PILGRIM NUCLEAR POWER STATION, UNIT NO. 1

Amendment No. 30
License No. DPR-35

ATTACHMENT TO LICENSE AMENDMENT NO. 30

SAFETY EVALUATION BY THE OFFICE OF NUCLEAR REACTOR REGULATION
SUPPORTING AMENDMENT NO. 30 TO FACILITY OPERATING LICENSE NO. DPR-35
BOSTON EDISON COMPANY
PILGRIM UNIT 1
DOCKET NO. 50-293

Figure 6.2.1

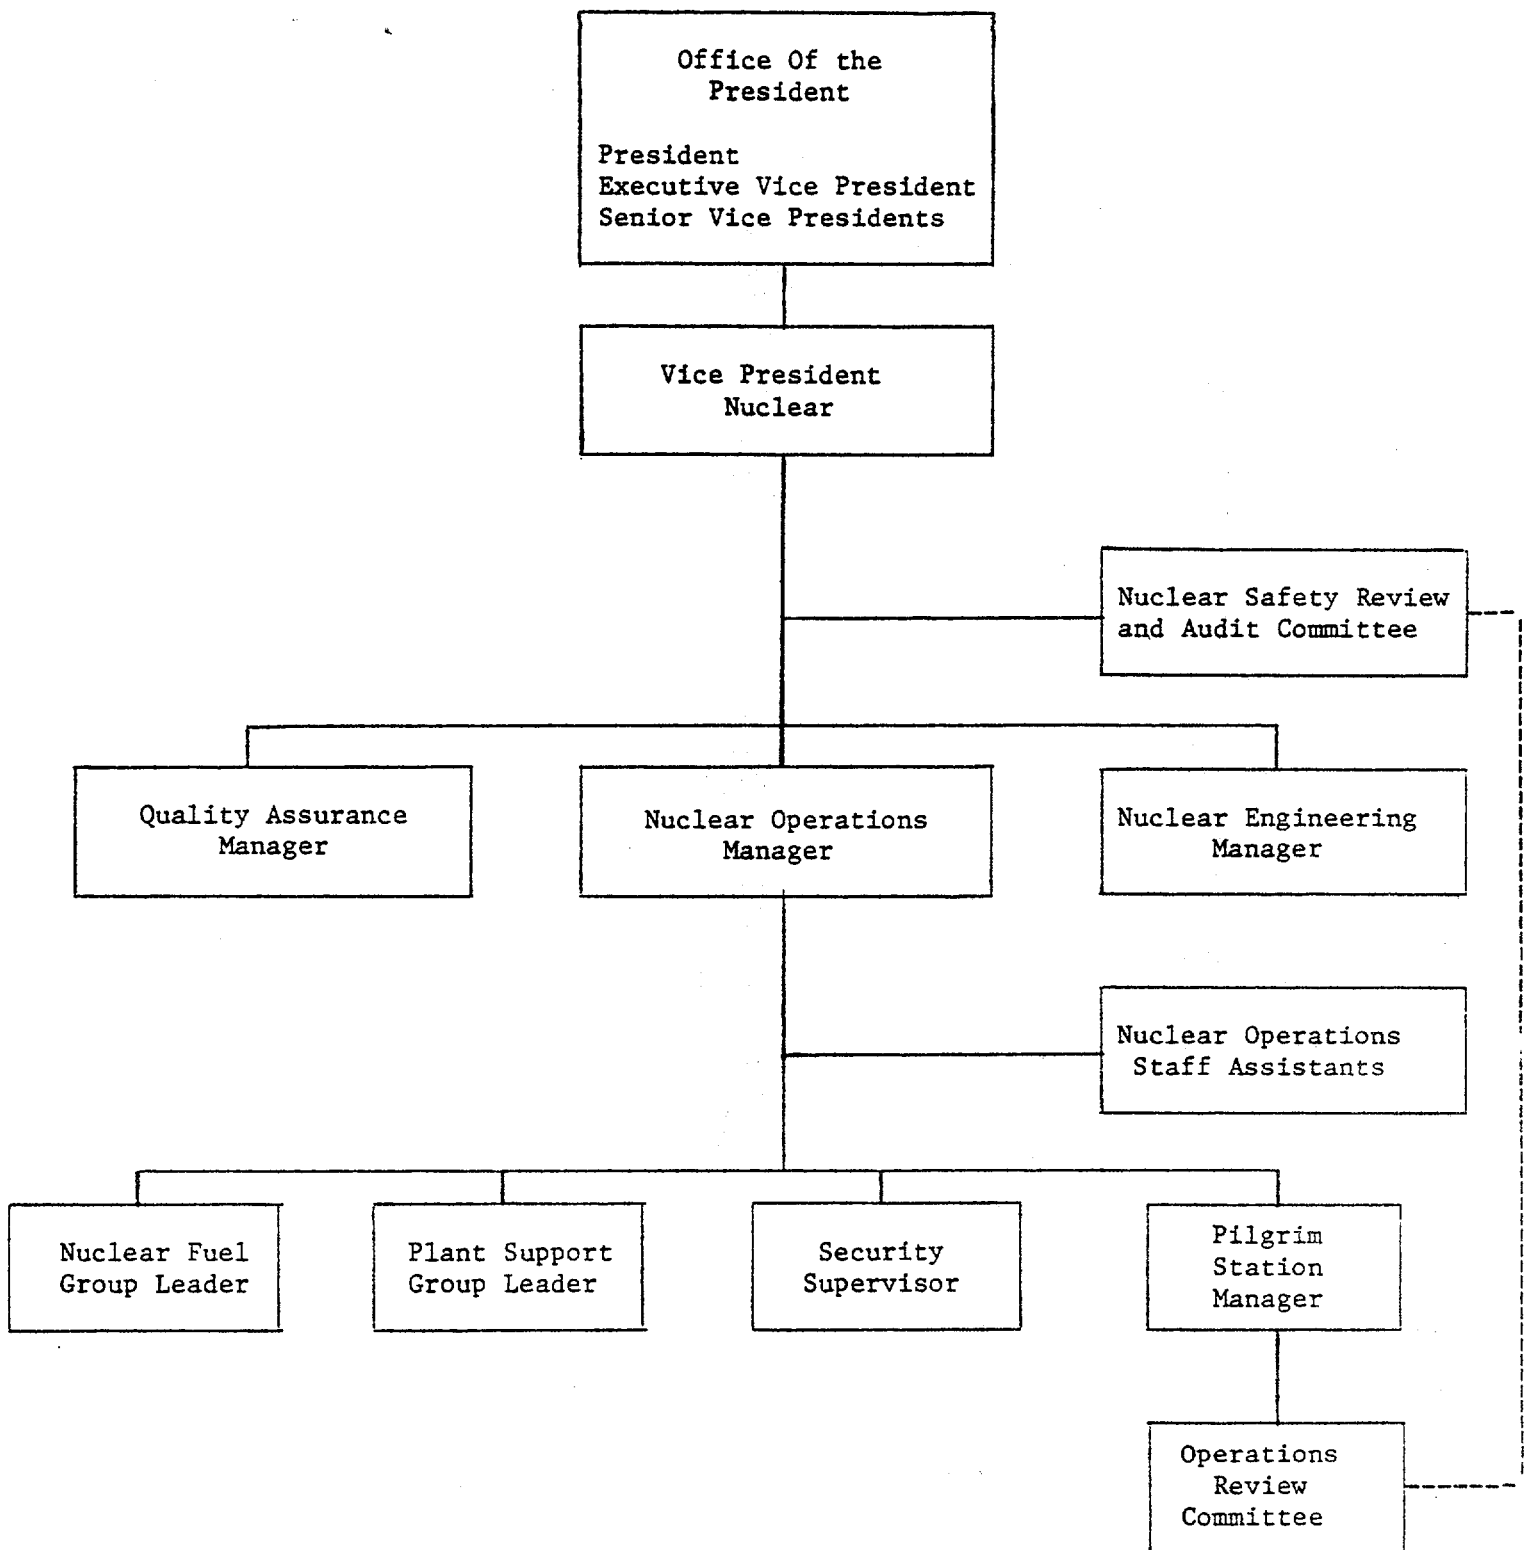
- (1) Figure 6.2.1 - Changes title of "Nuclear Licensing Administrator - Operations" to "Plant Support Group Leader".
- (2) Specification 6.5.A.2 - Change the title "Management Systems Coordinator" to "Methods, Compliance and Training Group Leader".
